RE: Data Response, Set 2C  
Ivanpah Solar Electric Generating System (07-AFC-5)

# Ivanpah Solar Electric Generating System (ISEGS) (07-AFC-5)

## Data Response, Set 2C (Responses to Data Requests: Closure & Restoration, Soil & Water, and Visual Resources)

**FIGURE DR140e-1**  
**TIRE WASH AND CONCRETE**  
**WASHOUT AREAS**  
IVANPAH SOLAR ELECTRIC GENERATING SYSTEM

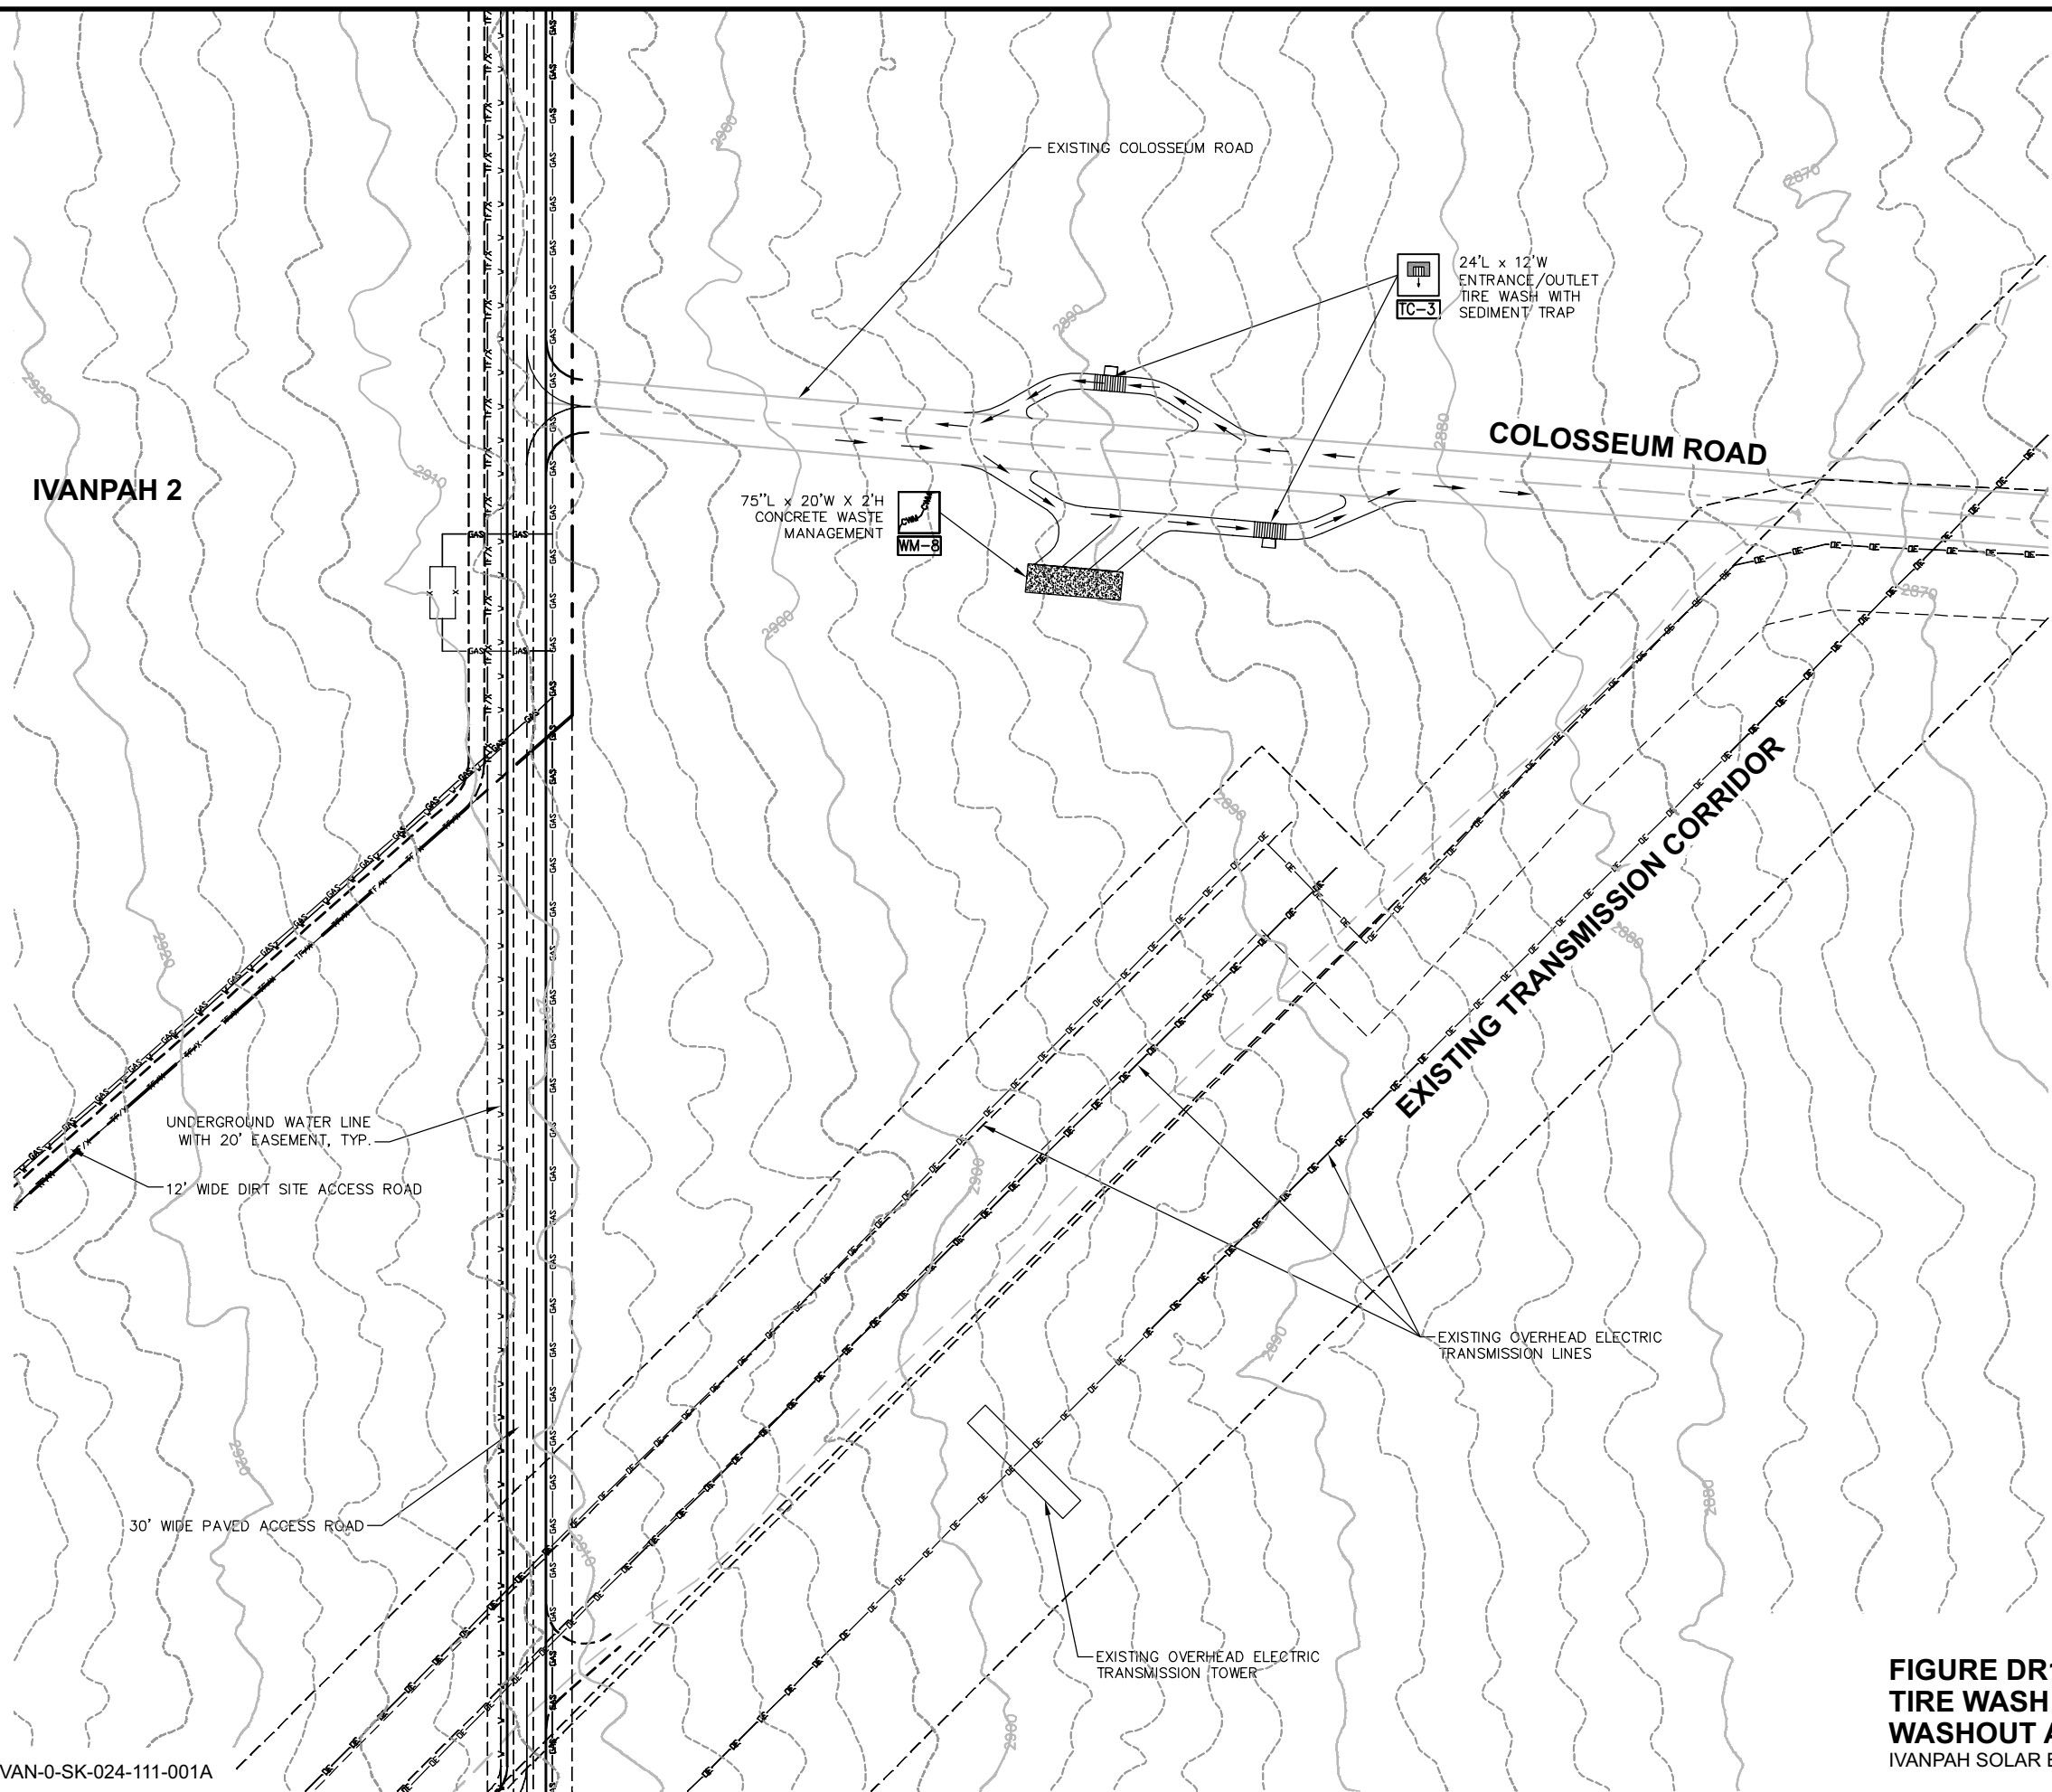
- e. Page 17 of the draft DESCPC states that there will be a concrete washout area used during construction. The location and size of this washout area need to be shown on a map of the project site and discussed in the text.

**Response:** The proposed location for the tire washing and concrete washout areas are provided in Figure DR140e-1.

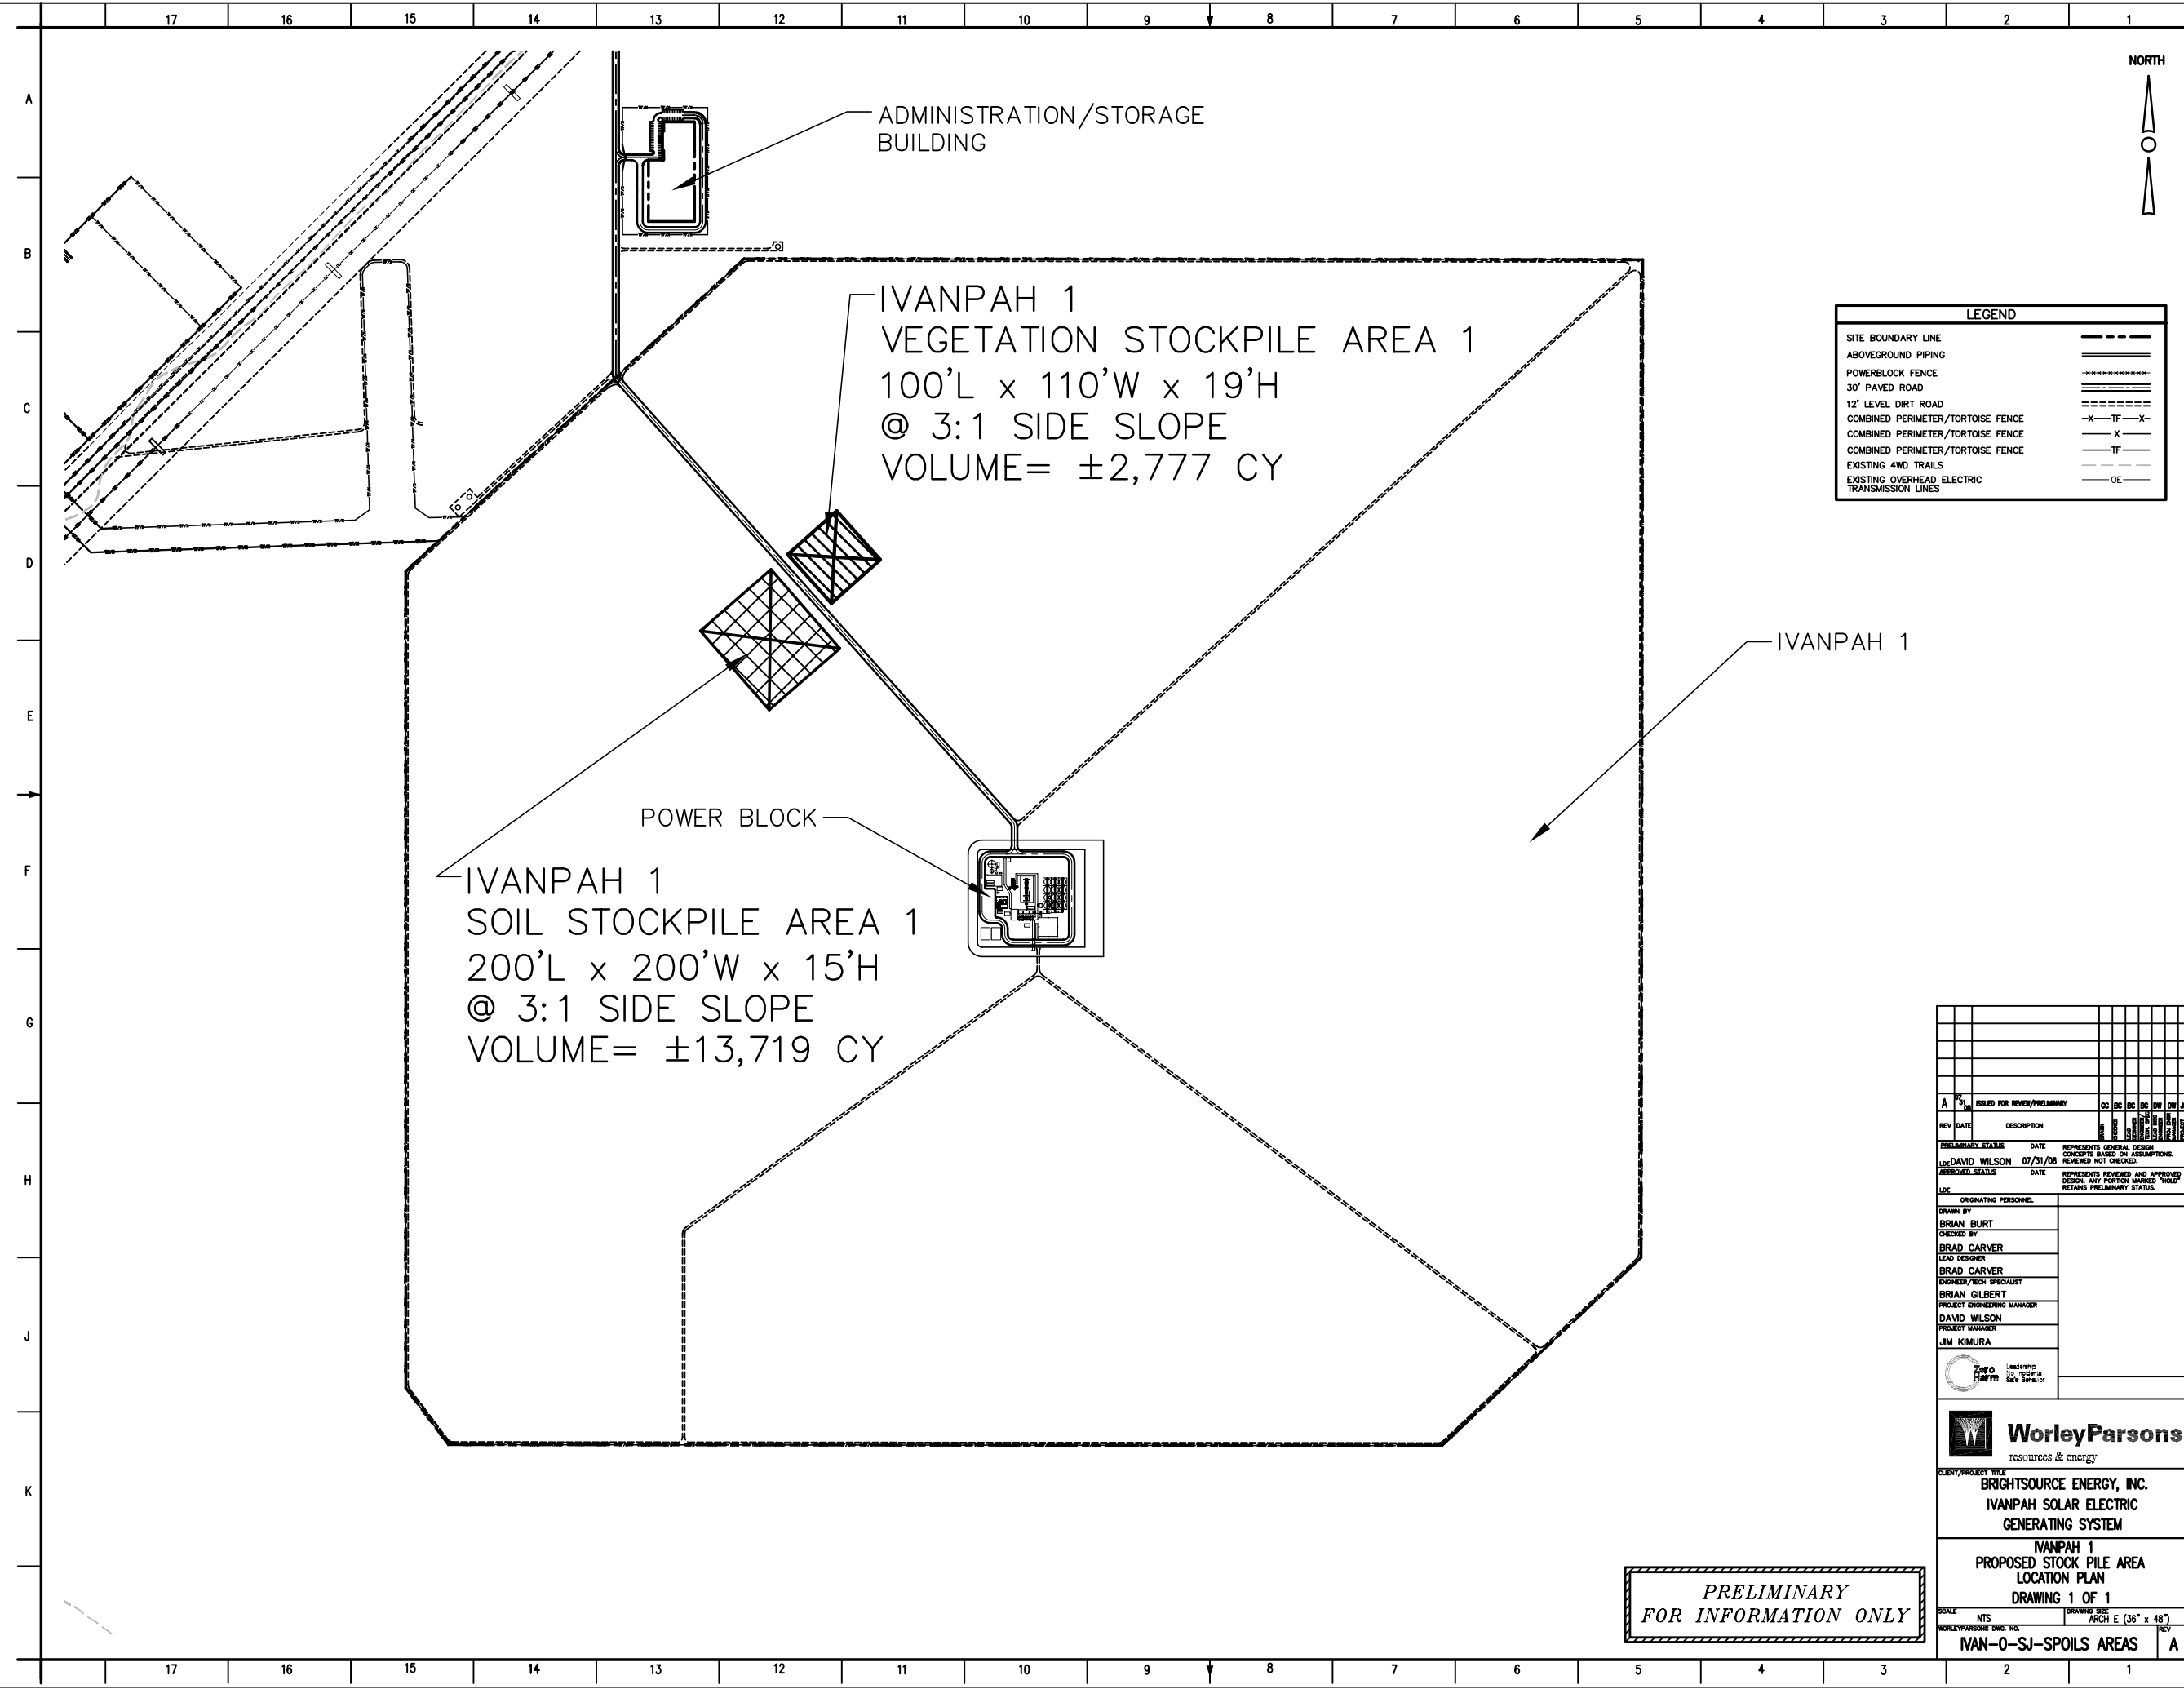
In response to Data Requests 63, the applicant provided a map of proposed stockpile locations to be used during construction. The stockpile locations for storing cut soil seem too small given the size of the project and the expected volume of soil and vegetation expected to be generated.

145. Please provide calculations supporting that the size of the stockpile locations are sufficient to support the volume of soil and vegetation expected to be generated.

**Response:** The temporary location(s) and area(s) where soil will be stored prior to the reuse within the sites biological surveyed area, and a calculation of the soil stockpile(s) for Ivanpah 1 are provided in Attachment 145-1.

The stockpile(s) for each of the Ivanpah SEGS units will be conservatively sized to support worst case conditions and will be protected by approved BMPs to minimize erosion. Stockpile(s) will be strategically placed throughout each unit to minimize haul distances. It is assumed that 4 inches of soil will be removed and stockpiled per acre. Additionally, a 10 percent expansion factor will be used for stockpile volume calculations. Only areas requiring major grading and leveling to light grading will require stockpile locations. For these areas, it is assumed that 30 percent of the total soil removed will be stored in the stockpile area. Soil will not be stockpiled in areas requiring only the clearing of vegetation to minor leveling (small cuts and fills).

Vegetation removed from the site is to be placed in vegetative stockpiles located adjacent to soil stock pile areas. For the purposes of sizing the vegetative stockpile area, it is assumed that 60 percent of the vegetation onsite will be removed with 25 percent of the total volume used onsite for soil stabilization and erosion control and 75 percent transported offsite for other uses or disposal. Approximately 2.5 acres of vegetation is assumed to be removed per day, producing approximately 370 cubic yards of mulch. Vegetative stockpile will be sized for only the 25 percent of the total volume used onsite for soil stabilization and erosion control. The location, area, and a calculation of the vegetative stockpile(s) for Ivanpah 1 are provided in Attachment 145-1.
